# UNITED STATES PATENT AND TRADEMARK OFFICE

APPLICATION NO.	FILING DATE	FIRST NAMED INVENTOR	ATTORNEY DOCKET NO.	CONFIRMATION NO.
10/673,510	09/30/2003	Noriaki Okazawa	Q77770	1658
65565 7590 06/06/2007 SUGHRUE-265550 2100 PENNSYLVANIA AVE. NW WASHINGTON, DC 20037-3213			EXAMINER FIDLER, SHELBY LEE	
			ART UNIT 2861	PAPER NUMBER
			MAIL DATE 06/06/2007	DELIVERY MODE PAPER

**Office Action Summary**

## DETAILED ACTION

Drawing A: Figure 2 of Miura et al., edited for clarification

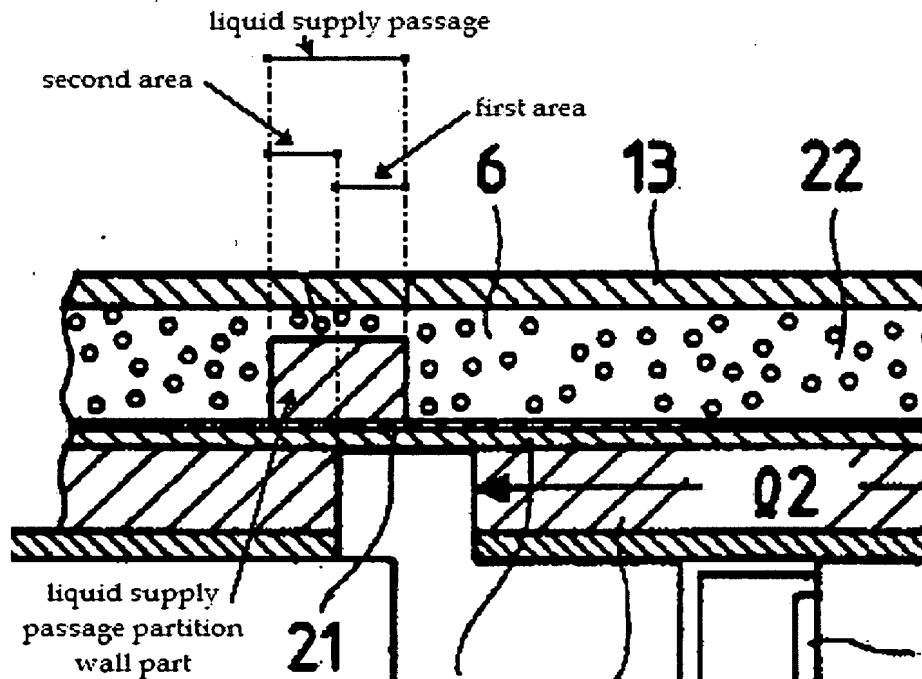
a plurality of liquid supply passages (liquid supply passages; see Drawing A below) that supply liquid to the pressure generation parts, respectively (Fig. 2);

wherein the partition wall parts respectively include liquid supply passage partition wall parts (liquid supply passage partition wall parts; Drawing A) that separate adjacent liquid supply passages (Figs. 1 and 2);

wherein the sealing section seals an area of the flow passage formation section corresponding to both the liquid supply passage partition wall parts and the liquid supply passage of the flow passage formation section (Fig. 1), and the sealing section has a first area (first area; Drawing A) and a second area (second area; Drawing A) that is greater in thickness than the first area (Drawing A);

wherein both the first area and the second area are opposed to the liquid supply passage (Drawing A); and

wherein the head case section is separated by a vacancy from the section at the first area opposed to the liquid supply passage (Drawing A and Fig. 2).

**Miura et al. also disclose that the metal thin film is formed on the sealing section of the portions corresponding to the partition wall parts as the second part (Drawing A).**

**Miura et al.** disclose all the limitations of claim 20, as well as the limitations that the second part inside of the area where the head case section is provided on the sealing section is placed in a part of each of the liquid supply passage partition wall parts (Drawing A).

Miura et al. also disclose that the second part is placed at a tip side away from the pressure generation parts in the liquid supply passage partition wall parts (Drawing A).

Miura et al. also disclose that the second part is placed only in the tip side of the liquid supply passage partition wall parts (Drawing A).

**Miura et al. disclose** all the limitations of claim 24, as well as the limitation that the second part of the sealing section (20b+24) is placed in the liquid supply passage partition wall part (Drawing A), to which the head case section is joined (Fig. 2), has an area smaller than an area of the corresponding liquid supply passage partition wall parts (Drawing A).

Miura et al. disclose all the limitations of claim 25, as well as the limitation that the second part (20b+24) inside of the area where the head case section (10) is provided on the sealing section is placed in a part of the liquid supply passage partition wall parts (Drawing A).
